Proposed Burlington Quarry Expansion Interim JART COMMENT SUMMARY TABLE – Hydrogeology

The following comments were provided by the Burlington Quarry Joint Agency Review Team (JART) on February 2, 2022 as interim feedback to assist with technical discussions between JART and Nelson, with the intention of finalizing the comments following those meetings. **These technical meetings took place on May 17, 18 and 19, 2022 and Nelson has advised JART that responses to these interim comments are forthcoming. JART will therefore be responding to these anticipated responses instead of finalizing the interim comments below.** Fully addressing each comment below will help expedite the potential for resolutions of the consolidated JART objections and individual agency objections. Additional, new comments may be provided once a response has been prepared to the comments raised below and additional information provided.

JART Comments (February 2021)	Reference	Source of Comment	Applicant Response	Interim JART Response (February 2022)
Report/Date: Level 1 and Level 2 Hydrogeological and Hydrological Impact Assessment Report, April 2020			Author: Earthfx Incorporated (July 2021)

Figure 2. Manual water level hydrograph of MP-5, SG-4, OW3-22B as well as at three adjacent wells (OW03-24B, 27B, and MW03-04B). The "Southeast Wetland" of Golder Associates Ltd. (2006) is equivalent to Wetland 17/13033 in the Earthfx (2020) report (Figure 19-50).

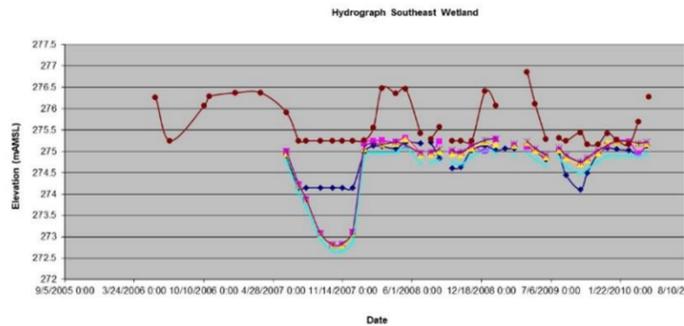
29. Figure 2 indicates that surface waters in the wetland are in fact directly connected to the underlying bedrock aquifer as shown by the precise correlation between the levels in MP-5 and all underlying wells. This behaviour is particularly well marked during the late Spring to early Winter period of 2007. The data are monthly, hence could mask some delay in response, however, such a direct correlation in levels as shown, even over monthly intervals indicate the presence of a direct hydraulic connection with the bedrock aquifer (compare to Figure 2 to Figure 1).

The juxtaposition of the MP-5 hydrograph (wetland 17/13033) and staff gauge 4 with the underlying bedrock wells demonstrate a very rapid decline perfectly co-incident with the three bedrock wells shown in the figure 1 provided (OW03-22B, 24B and 27B) during the dry 2007 period. Both the decline at the beginning of the season and the rise at the end of the season are obviously directly connected. This unequivocally shows a strong, direct hydraulic connection between the wetland and the underlying bedrock aquifer at this location. Thus the wetland will be directly impacted to the degree quarrying lowers the underlying aquifer's surface.

Figure 3: Aquifer pumping test results showing water levels in bedrock wells (OW03), the wetland surface (MP-5), and a staff gauge (SG-2) in the southeast wetland during February 2006 (Golder Associates Ltd.

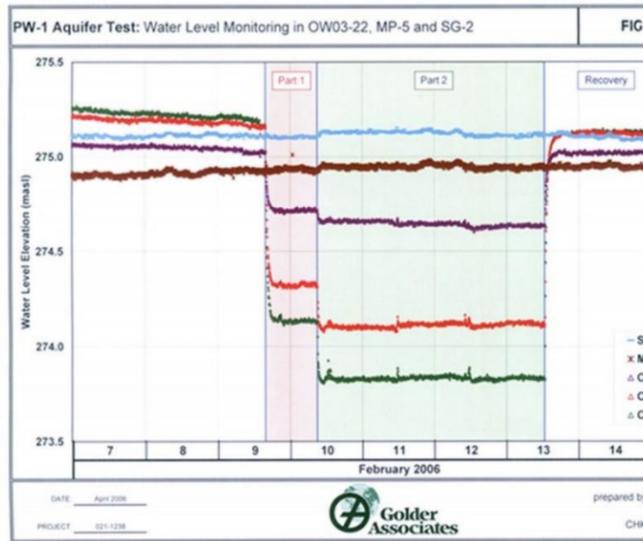
30.	<p>Figure 3 shows the results of a 6-day pumping test in bedrock wells located near MP-5 and SG-2 during February 2006. The lack of any evident response in the mini-piezometer and staff guage (brown and blue lines, respectively) was provided as proof of the aquitard characteristic of the Halton Till. However the next year – 2007 – was a drought year and the full year hydrograph for the wells, mini-piezometer and staff guage demonstrate a direct connection (Figure 2). It is clear that a 6-day pumping test is not long enough to determine connectivity.</p>	<p>General</p>	<p>Daryl W. Cowell & Associates Inc.</p>	<p>No. The pumping test was a direct local stress on the aquifer. The system responded and reached equilibrium in an extremely short time with no indication of a significant impact on the wetland. Prolonging a test after equilibrium is reached makes no hydrologic sense. That both the shallow system and bedrock respond to seasonal change indicates that, on a regional scale, sparsely-spaced deep vertical fractures provide a higher degree of connectivity than would occur through an unfractured till. As in the bedrock, the occurrence of these vertical fractures is random and not mappable. A 30-day pump test would not provide any additional information in this regard.</p>	<p>There are two systems here – the wetland system (MP-5 and SG-2) did not respond at all during the 6-day pumping period. You will note that pumping test well (OW03-22B) did show a direct correlation of wetland and aquifer levels (yellow in preceding figure) during the dry 2007 period which was effectively a four-month pumping test.</p> <p>B.2 Section 2.4.2 Golder In-Situ Test and Pumping Test</p> <p>Page 975 and Figure 8, page 981. I had spoke to this in my original comments on the report and responded to Earthfx's response to the JART Table (my comments #29 — 30). Pumping a well over only 4 days draws down the well, it does not draw down the aquifer. As I noted before, the pumping test should have been conducted in the order of 30 days. The 2007 dry year was effectively a 4-month pumping test, demonstrating a hydraulic connection between wetland 13033 and the underlying aquifer.</p>

Figure 1a. Location of springs A to K, sinking streams near the quarry, and locations of the photos (circled numbers) shown in Figures 2 to 7.

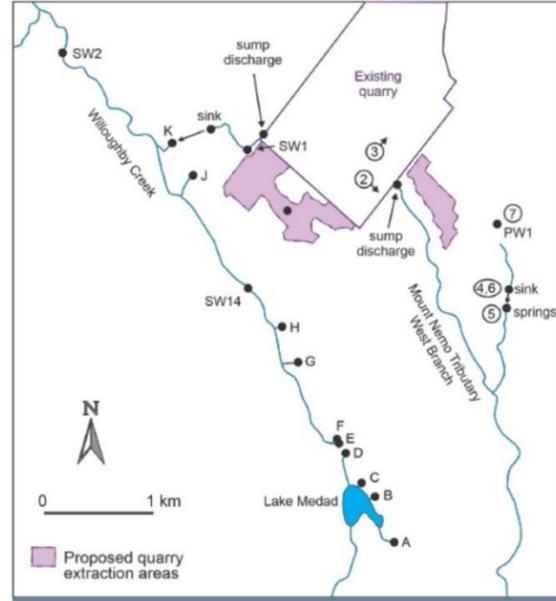
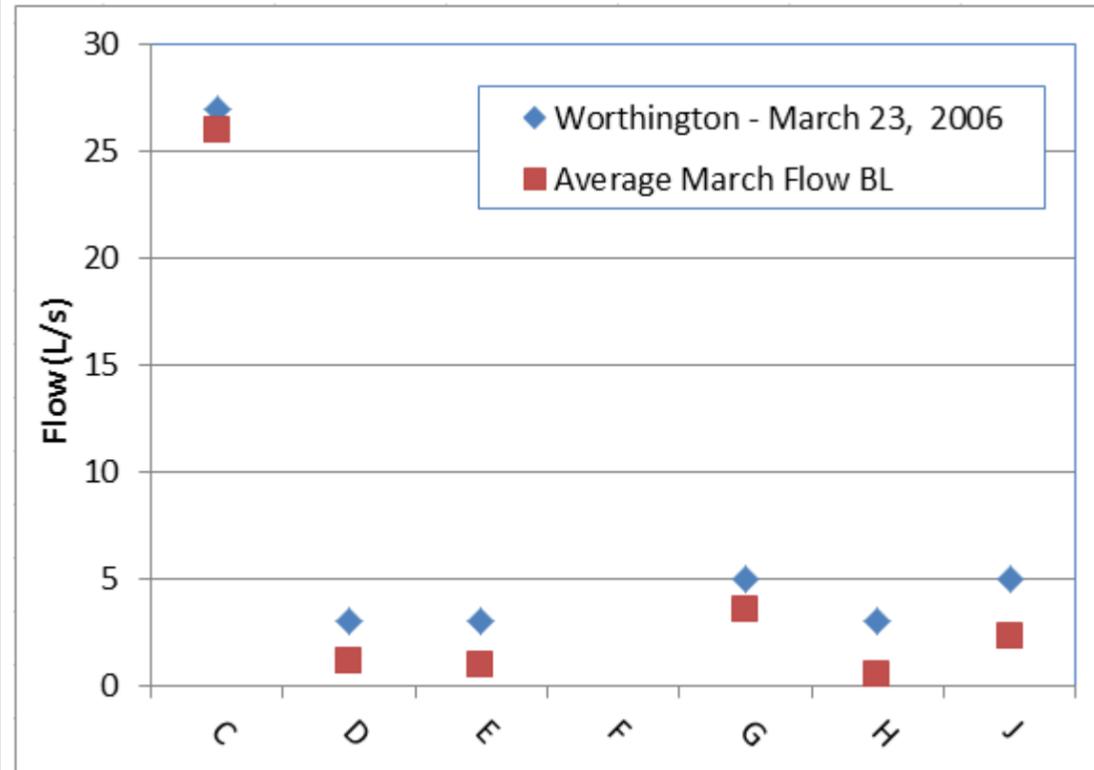
41. Worthington (2006 and 2020) documented the presence and location of 10 springs in the Medad Valley. He provided one-time flow estimates (March 23, 2006) that ranged between 3.0 and 32.0 litres/second at the time of observation. Springs G, H, J, and K are all within about 1.0 kilometre of the western extension and spring J is within about 500.0 metres (see Worthington Figure 1a below). These four springs have a combined flow estimated at 45.0 litres/second.

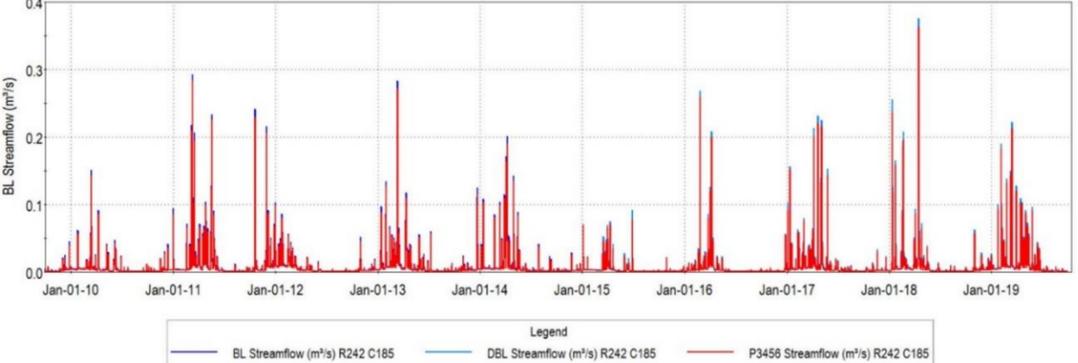
Below is a graph comparing Worthington flows against the average March flow predicted by the model under baseline conditions. The pattern in the simulated water levels appear reasonable (e.g., high simulated values match high observed values) but are consistently lower. Spring flows vary on a daily basis. It should be noted that 2006 had higher annual precipitation than any successive year. There were 47.1 mm of rain in March 2006 (30-year average for March = 43.3) prior to the Worthington measurements and January and February precipitation values were well above the monthly averages (79.1 vs. 56.8 for January and 84.1 versus 57.2 for February, respectively) so it is not unexpected that the Worthington instantaneous measurements are higher than average simulated March flows.

It should be noted that the Worthington measurements were not used as calibration targets. This post-analysis verifies that the calibrated model captured key features of the hydrologic and hydrogeologic conditions in the study area.

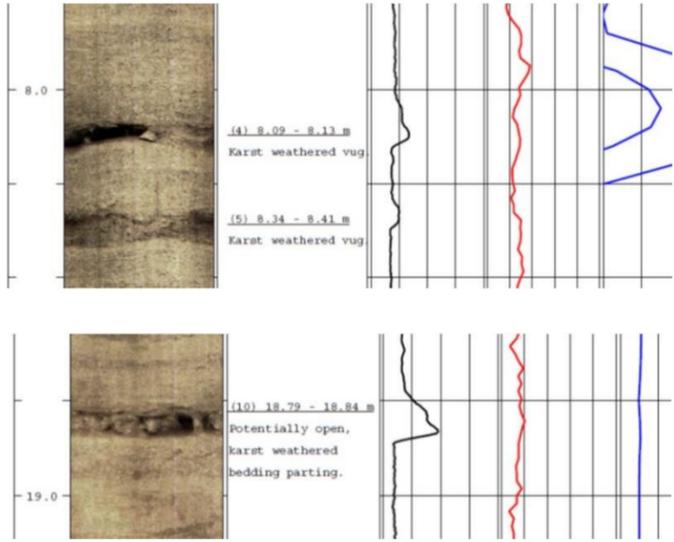
Where did this figure come from? What are the assumptions/data used to create it? It seems to contradict Worthington's response to my comment #55 that "EPM models do not simulate flow in individual fractures".

Figure 19.22: Comparison of observed and simulated water levels at monitor OW03-15.

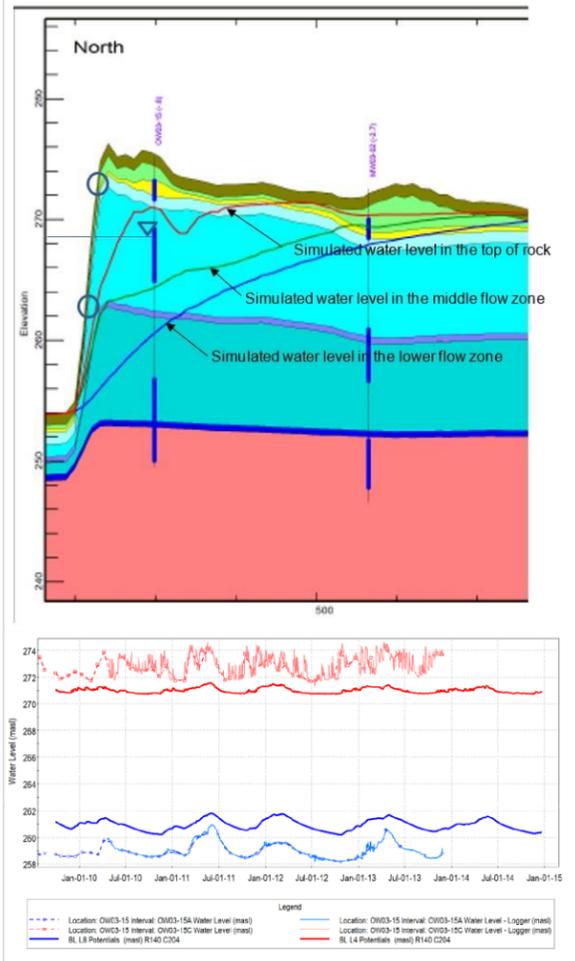
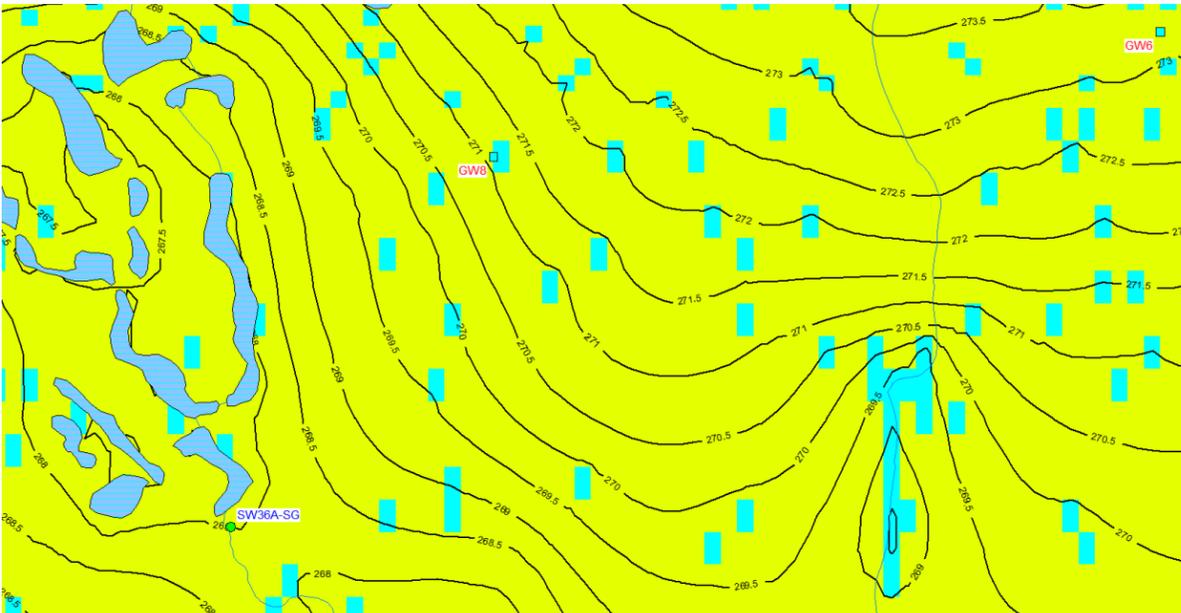
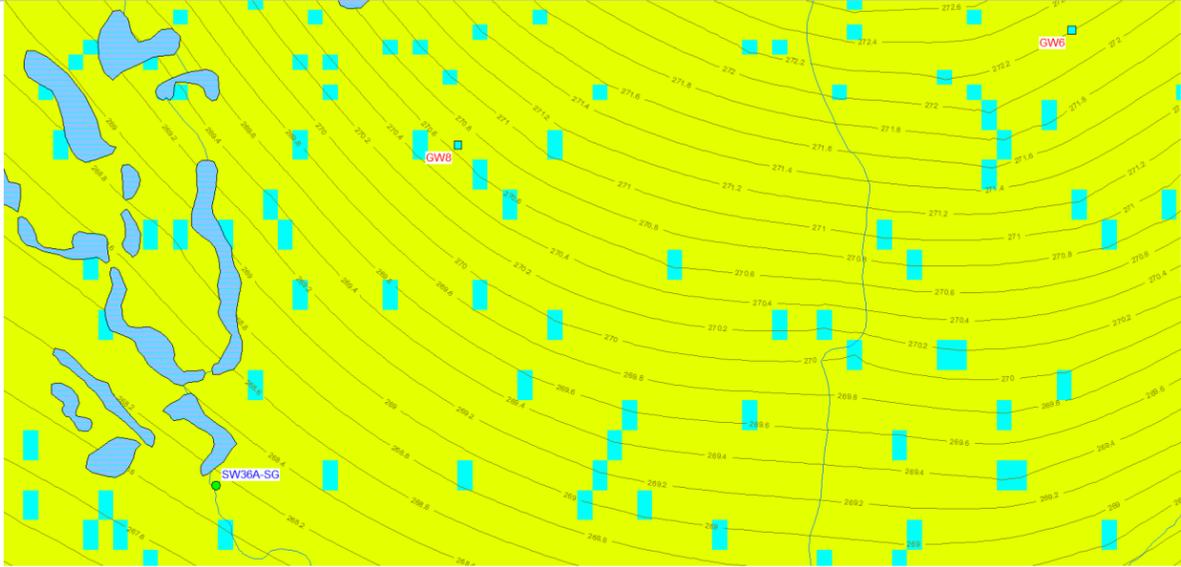
Referring to the hydrographs for OW03-15, it appears that the simulated water levels are about 2 m below the average observed levels in the C and A monitoring intervals.

The results shown in Figures 5.2-5.4 and 19.18-19.20 of the report illustrate why the representation of conditions along the Medad Valley and Niagara Escarpment and around the existing quarry is important. A portion of Figure 19.18 is reproduced below. There is no evidence to suggest that the water levels in the weathered top-of-rock and in the middle flow zone decline steeply as predicted with the model.

Hydrographs for observation well OW03-15 between April 2003 and July 2010 and between July 2009 and January 2015 are reproduced here on page 9. The long-term average water levels in the shallow “C” and deeper “B” and “A” monitoring intervals are about 273.0 metres, 269.0 metres and 259.0 metres amsl, respectively. Since 2003, the water levels have varied by only about ± 1.0 metre with respect to the average levels. The water levels are controlled by the elevations at which the flow zones daylight at the quarry, indicated by the circles added to the excerpt from Figure 19.18. The non-physical simulation approach that has been adopted compromises severely the reliability of predictions of potential impacts of the quarry extension.

If you examine Figure 19.18, you will see that the water levels are, in fact, controlled by the elevations at which the flow zones would daylight at the quarry. It should be noted that there is a zone of fill that was emplaced along the quarry face that is represented by the model.

A significant effort was made to create the distribution of heads seen in Figure 19.18. The objective was to match the observations of change in head as the quarry face approached the property boundary.

Figure 5.12: Water levels recorded in Monitoring Well OW03-14 (175 m to 40 m fr

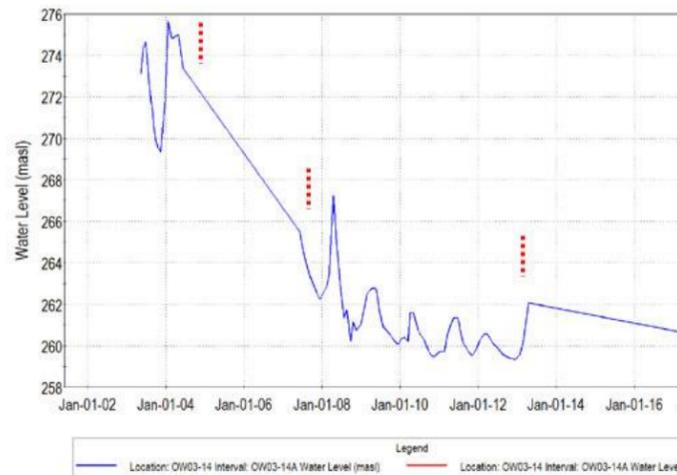
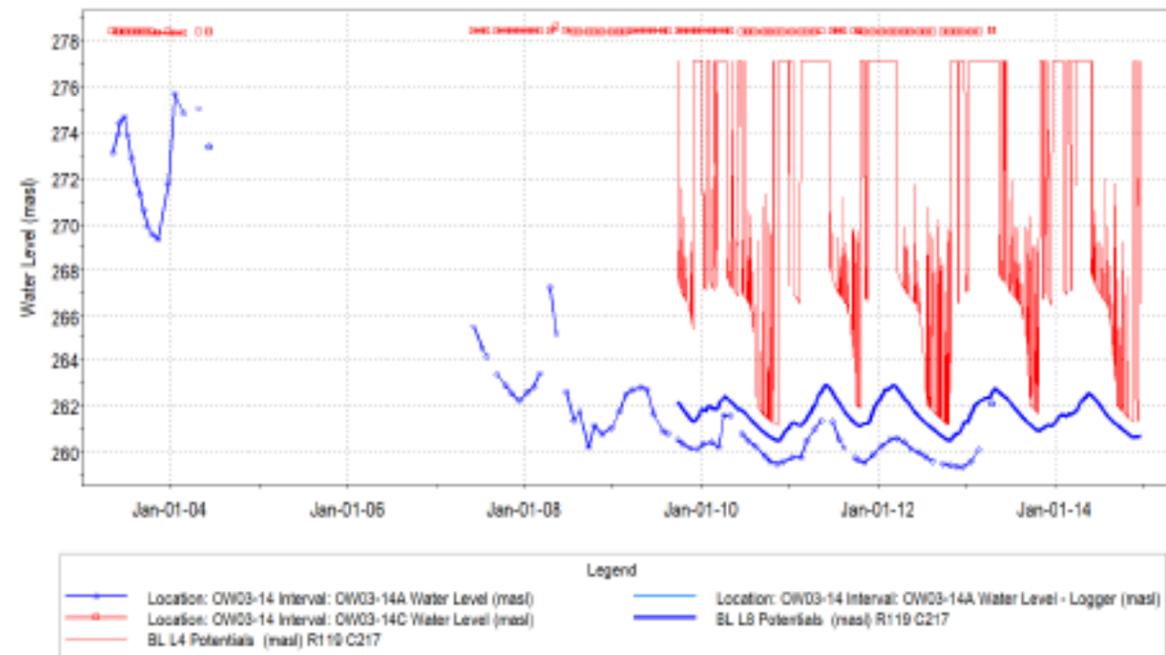
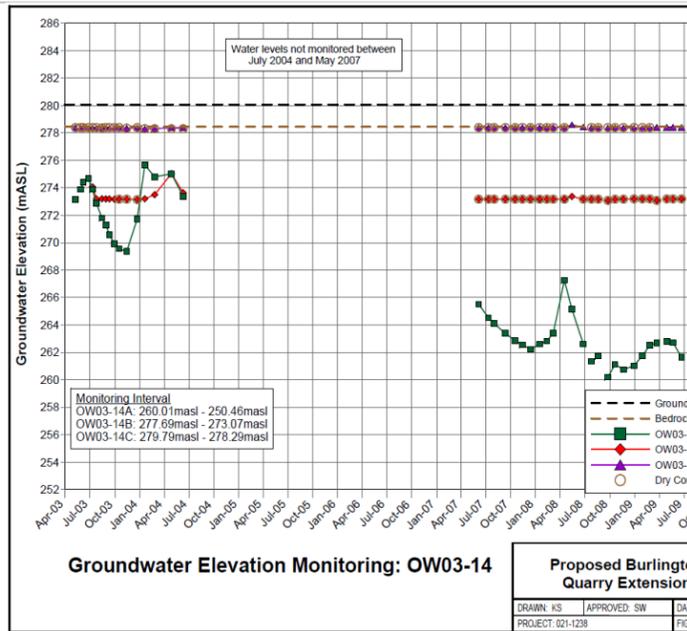
It is clear that the failure of the reviewer to understand these complex integrated model processes has resulted in his inability to complete the review as stated in Comment 61. Further, it is also apparent that the reviewer does not appreciate that representing the complex interaction of integrated model processes (“Process complexity” mentioned in Comment 63) is more important than an approach *“where the parameter estimation chases noise in the observations”* (“Parameterization complexity”) (Hunt et al., as above). There is likely no amount of model K field parameterization and parameter estimation that will recreate the interaction of climate, soil zone processes, Halton till leakage and quarry drainage processes. Processes matter.

130.	<p>'A hydrograph from monitoring location OW03-15, south of the 2nd Side Road (see Figure 3.4) is shown in Figure 5.11. Water levels in the deepest monitor (OW03-15A) at this location are over 13 m below those of the water table (OW03-15C), clearly indicating that the lower system is connected to the quarry by a permeable lower fracture.'</p> <p>The above statement suggests that the existing quarry is draining the lower flow zone. What is the extent of the quarry influence on this flow zone?</p>	Page 106 Section 5.2.8. Lower Flow Zone, 1 st Paragraph	Norbert M. Woerns	<p>As noted in the report, there are strong head differences between the shallow and deep system near the quarry face and, as noted, the outcrop of the lower fracture zone is likely helping to drain the deeper system. Leakage from above contributes to the inflow but at a rate that cannot bring the heads up to near shallow bedrock levels. Further from the quarry, at about 300 m of the quarry face, lateral flow towards the quarry face is better balanced by leakage from above and the head differences are much smaller.</p> <p>This is directly analogous to flow to a well in leaky aquifer.</p>	What is the expected area of influence of the existing quarry excavations in the lower system?

131.	<p>'A hydrograph from monitoring location OW03-15, south of the 2nd Side Road (see Figure 3.4) is shown in Figure 5.11. Water levels in the deepest monitor (OW03-15A) at this location are over 13 m below those of the water table (OW03-15C), clearly indicating that the lower system is connected to the quarry by a permeable lower fracture.'</p> <p>A similar pattern is observed in monitor nest OW03-14 (Figure 5.12). When the monitor was installed in 2004, the quarry face was 175 m from the monitor (Figure 3.8). Between 2004 and 2009 the quarry face advanced to within 40 m of the monitor, and during that time the heads in the lower system dropped 14 m. This provides particularly useful information, for it suggests that the quarry influence is less than 200 m from the active face.'</p> <p>A much larger zone of influence of up to about 1000.0 metre is indicated in East Calibration Section, Figure 6.2.3 page 148. Have the impacts of the existing quarry stabilized or are the drawdowns continuing? A figure showing the cone of influence and drawdown from the existing quarry should be provided.</p>	Page 106 Section 5.2.8. Lower Flow Zone, 1 st and 2 nd Paragraph	Norbert M. Woerns	<p>Head differences decrease relatively quickly with distance from the quarry face. At the quarry face there is about a 15 m difference between Layer 4 and Layer 8 heads. This decreases to about 5 m within 300 m from the face. By 600 m there is no difference between Layer 4 and Layer 6 heads and about a 1 m difference between Layer 6 and Layer 8. By 900 m, there is no difference in the simulated water levels. This is generally consistent with the observations, but the reviewer is correct that the model shows a slightly higher degree of influence and the model would tend to over-predict the impact of quarry expansion.</p>	The model predictions of the area of influence of about 1000m appears to be a reasonable approximation of the measured water levels within bedrock flow zones. It is unclear whether the area of influence of the existing quarry has stabilized or is still expanding.

There are many ways to present the data. In Figure 19.23, the same data are presented with the gaps shown. Here, the figures were drawn to highlight the decrease in head.

Figure 6.26: Comparison of observed and simulated water levels at monitor **OW03-31** (Note: deep

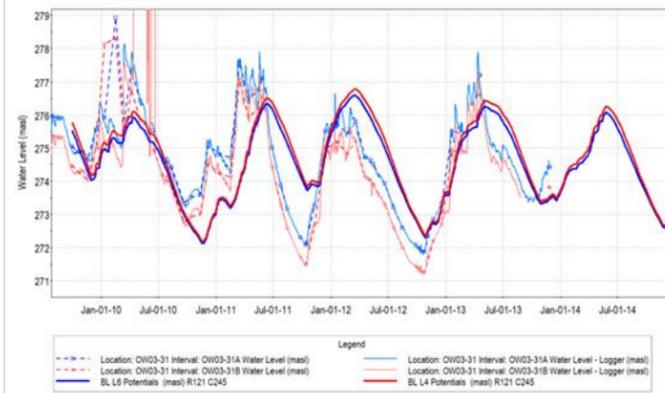
It should be noted that the model does not simulate groundwater levels well in this area as visible on Figure 6.26:
